Our Reference: SYD20/01320/06

Departments Reference: SSD-11070211

**EXHIBITION OF EIS - NEW PUBLIC SCHOOL IN MULGOA RISE - 1-23 FORESTWOOD DRIVE
- GLENMORE PARK**

Attachment A

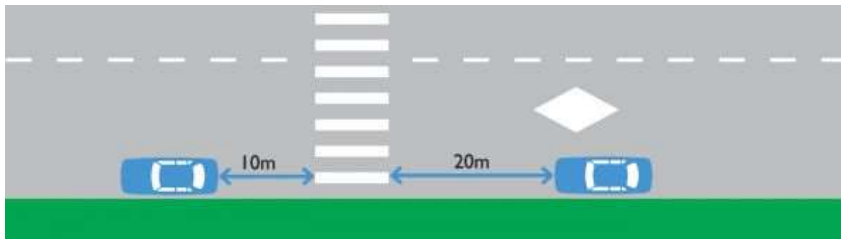
TfNSW provides the following traffic and safety comments to be addressed for further review. It should be noted that several of these issues were raised at meetings with the applicant, Council, Department and TfNSW:

- a. 5.2.4.1 & Attachment 2 (Pedestrian Crossings) – Bus Bays need to be located sufficiently away from the crossing to ensure sight lines are not obstructed in line with Australian Standards (this also needs to consider how many buses may simultaneously be present, especially at bus stop B);

In addition the bus bay is to have sufficient length (consider draw-in length, draw-out length, and maximum number of services expected at any one time) to ensure that buses can be fully contained within bus bay;

- b. 5.1 - The amount of parking spaces shown in Figure 41 will need to be revised as the below minimum buffer is required at zebra crossings;
